# Landscape assessment peer review report

**APPLICATION REFERENCE:** Private Plan Change 54 Northlake Investments Ltd

**DATE:** 16 May 2023

Figure 1: Mitigation landscaping plan for water reservoir above the plan change area.

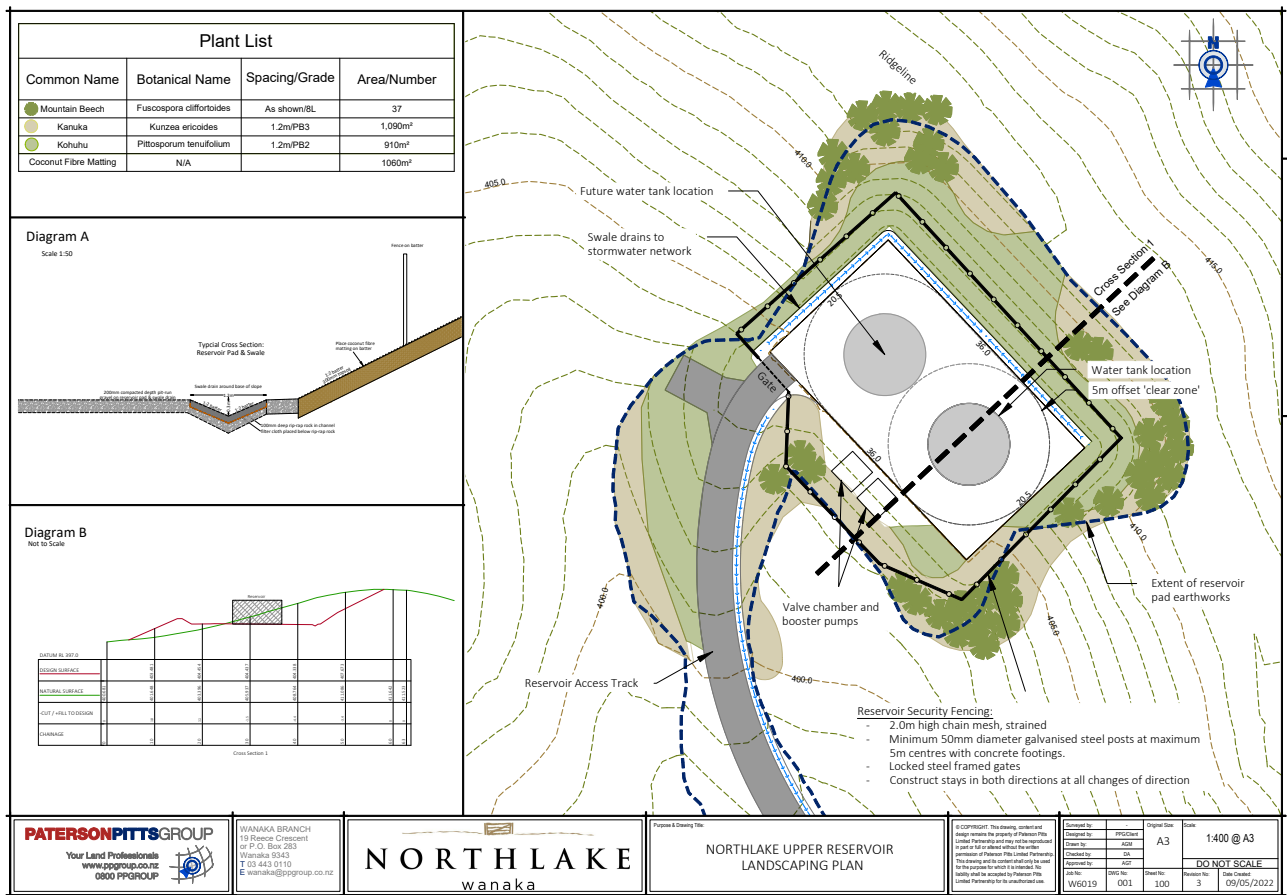
- I agree with the Patch LSA that PC54 would not have any adverse effects on the character and values of the Lake Wānaka ONL. Although the boundary of the ONL is only about 100-150m from the plan change area, development would not be visible from points further within the ONL. From the crest of the ridge that marks the ONL boundary, both within Northlake and within the Sticky Forest site, the proposal would be seen within the context of other existing or anticipated urban development to the south. There is potential to extend the indigenous planting required as part of the reservoir consent (refer **Figure 1** below) to the north-west and south-east to partially screen development within the proposed B6 Activity Area that is closest to the ONL boundary.

29. Adverse visual effects experienced from the ridgetop ONL boundary to the north and north-west, could be mitigated by additional native planting west and east of the water reservoir.

Figure 2: suggested E1 activity area in south-western corner of proposed plan change area.

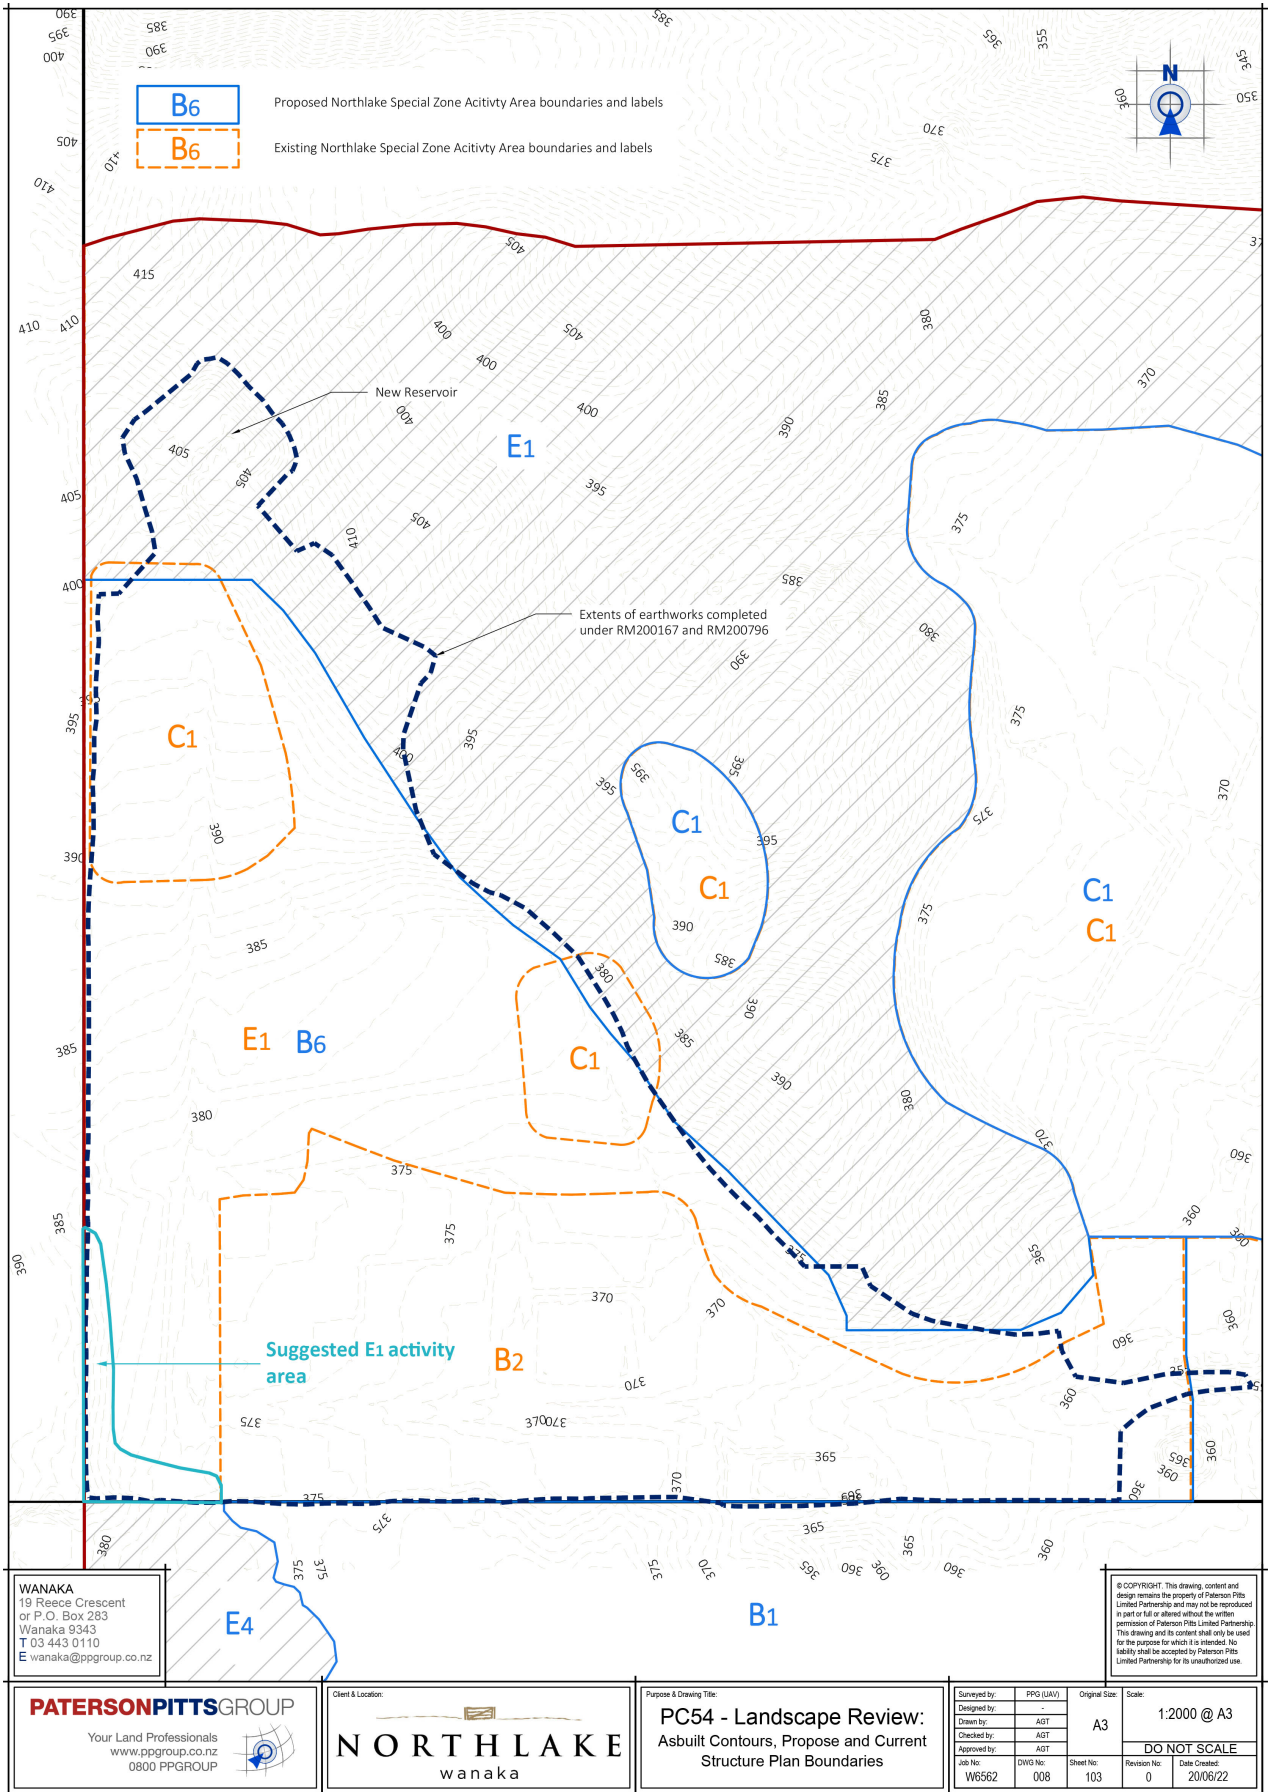
14. The plan change would facilitate dwellings on the toe slopes in the south-western corner of the site, and there would be a sharp mismatch between urban development in B6 activity area and retained open space in E4 activity area to the south. From a landscape character and visual amenity perspective, it would be preferable to retain a smaller E1 building restriction area in this corner that covered the steeper toe slopes (refer **Photograph 2** above) and aligned to some extent with the E4 activity area to the south. The consented Outline Development Plan for the WHF Properties Ltd land south of the plan change area includes a public open space and walkway connection within the northern part of E4 (refer **Figure 1** below). A suggested extent for the additional E1 building restriction area is shown in **Figure 2** below.

28. The proposal would reduce the open character, legibility and naturalness of the landscape, and the recreational value of the open spaces within Northlake. However the adverse landscape effects would be low-moderate, and not significant, in extent. Cumulative adverse effects on landscape character and values could be mitigated by removal of the C1 Activity Area east of the plan change area and by retention of a building restriction area on steeper slopes in the south-western corner of the site.
